**Millstone Nuclear Power Station, Unit No. 3
Response to Request for Additional Information,
Spent Fuel Pool Rerack (TAC No. MA5137)**

**Response to Request for Additional Information
Spent Fuel Pool Rerack (TAC No. MA5137)**

**Response to Request for Additional Information
Spent Fuel Pool Rerack (TAC No. MA5137)
Additional Questions Regarding Heavy Load Handling**

**Additional Questions Regarding Heavy Load Handling
Rigging Configurations - Exhibits 6.5.1 through 6.5.5**

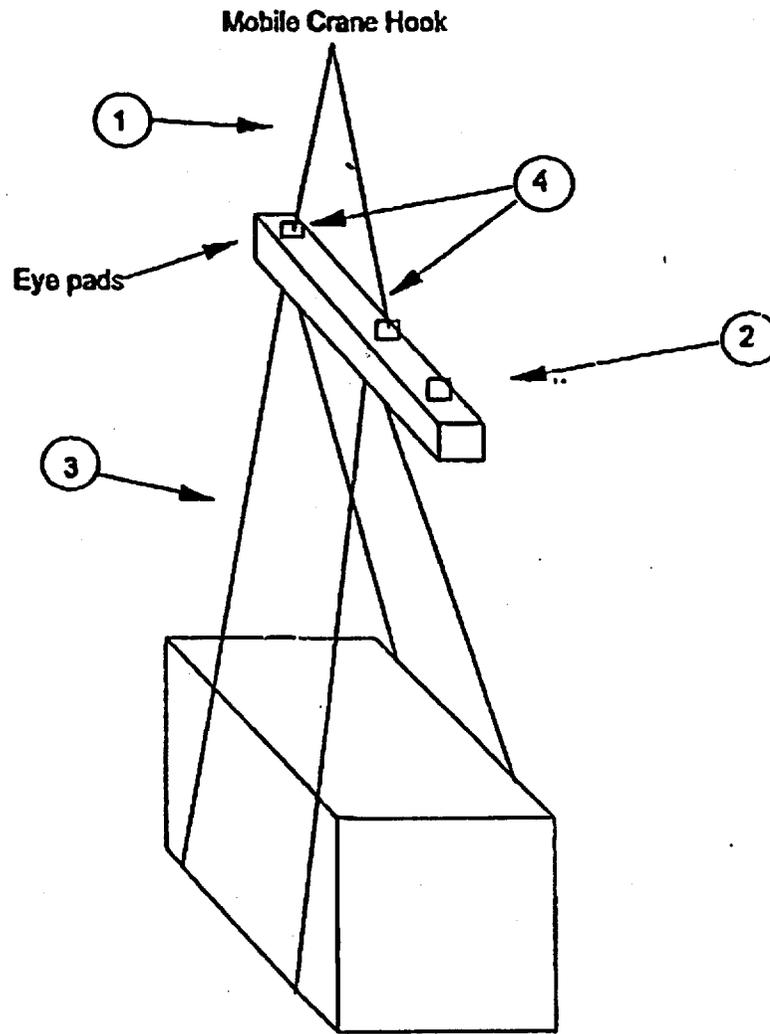
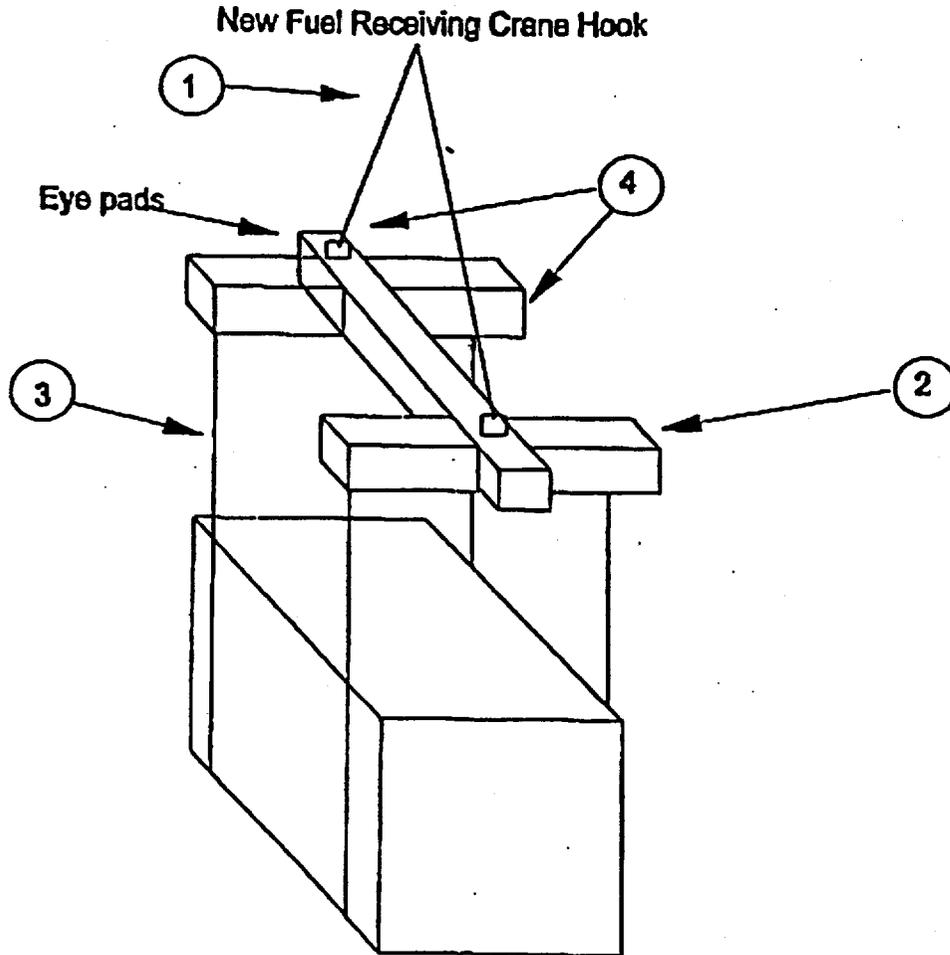
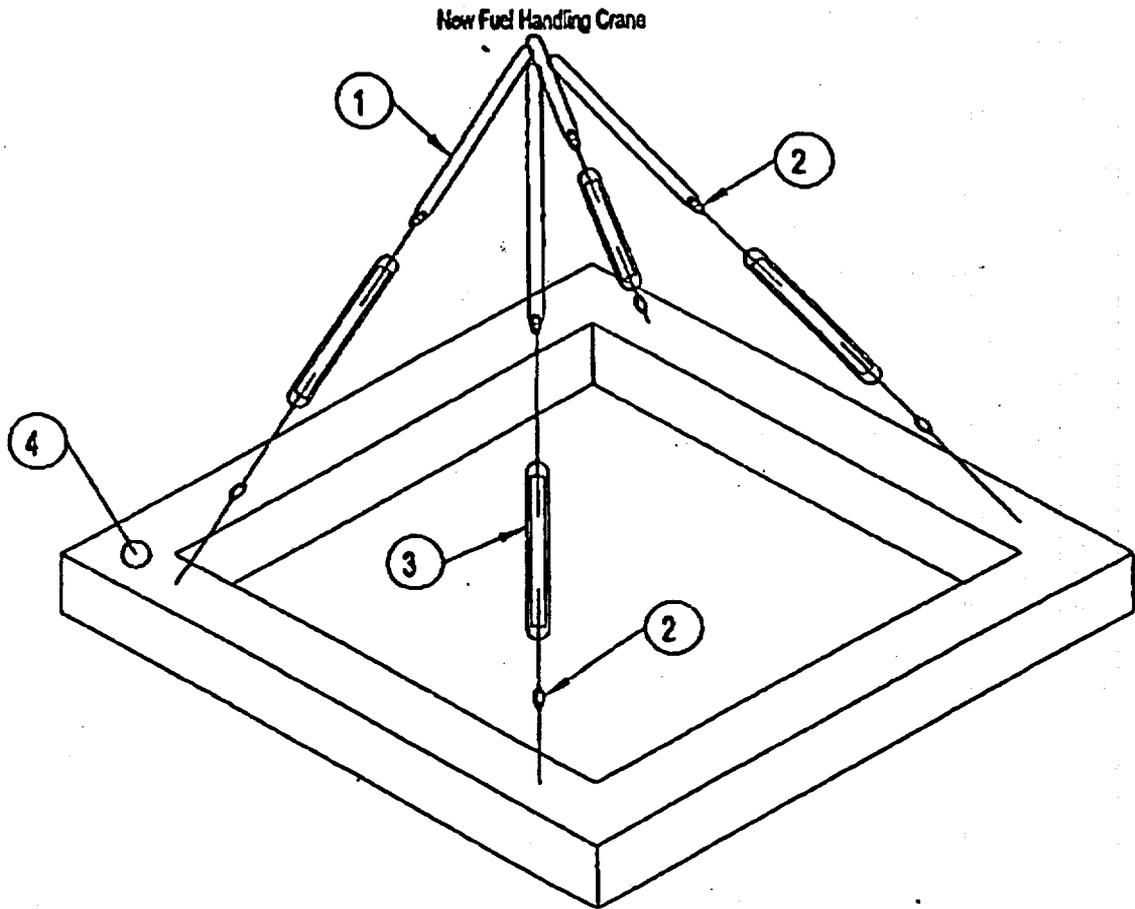
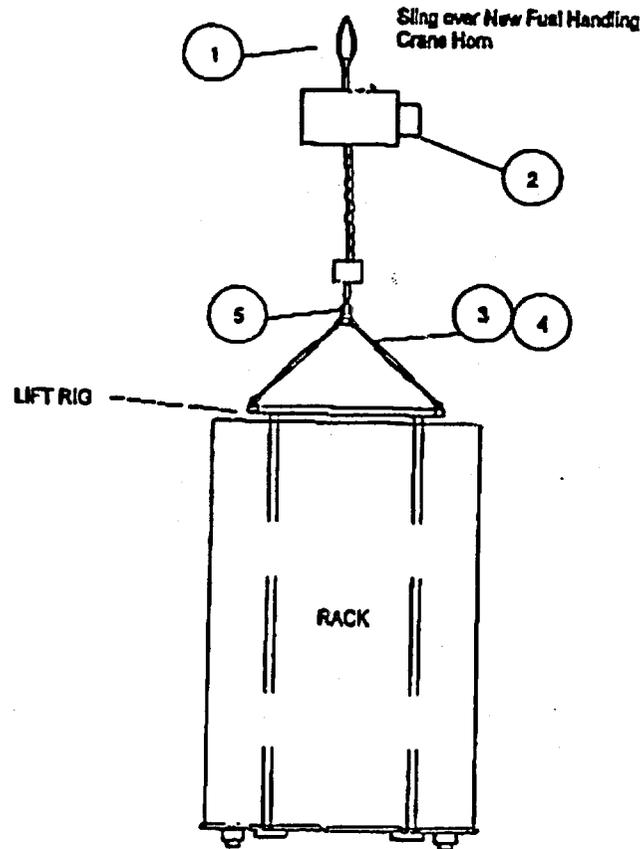
1. Regarding lifting devices described in Section 3.3 of the Holtec Licensing Report, provide additional detail with respect to the use of installed equipment and its interface with vendor supplied lifting devices, and the design and qualification standards applied to vendor supplied lifting devices.

5. Clarify item 5 of Table 3.5 regarding use of "non-customer" lifting devices.

Information related to vendor supplied lifting rigs is provided in Section 3.3 of Attachment 5 to the March 19, 1999,⁽¹⁾ submittal. Further details are provided herein as Enclosure 1, which contains five figures depicting the rigging arrangements to be used in handling the storage rack assemblies. These figures are excerpted from the NNECO approved Millstone Vendor Procedure entitled "Onsite Handling & Installation Procedure" to be used by Holtec, and are identified as Exhibits 6.5.1 through 6.5.5. Additional information regarding the required ratings of the components to be utilized is also provided on these figures.

The reference in this entry is to vendor supplied lifting devices. These lifting devices are depicted on the figures provided as Enclosure 1 to this submittal.

EXHIBIT 6.5.3
RIGGING CONFIGURATION FOR RACK UPENDING

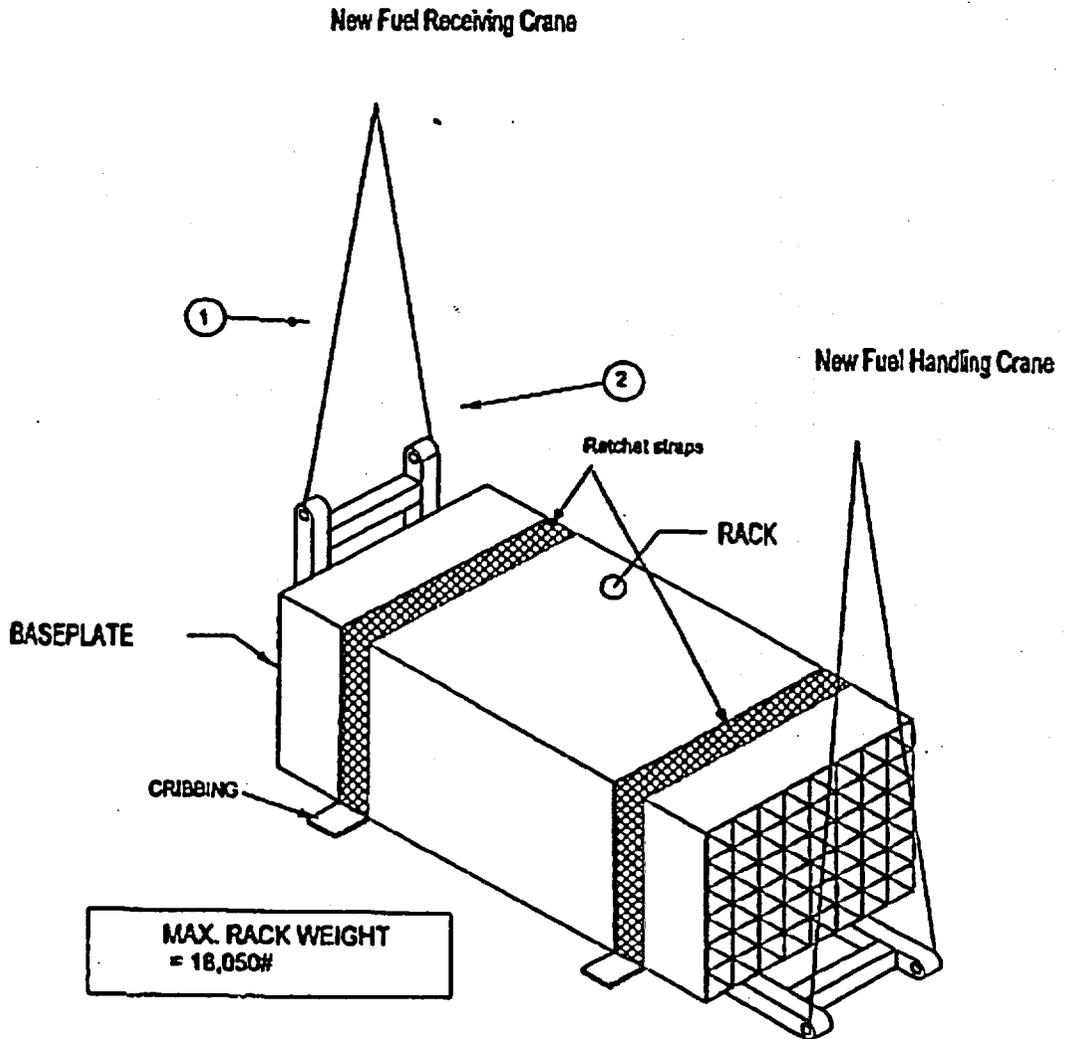
6. Clarify the discussion at the beginning of Section 10.5 of the Holtec Licensing Report regarding upending operations.

The Exhibit 6.5.3 of Enclosure 1 illustrates the rigging arrangement for the upending process as well as the designated cranes to be used in this process.
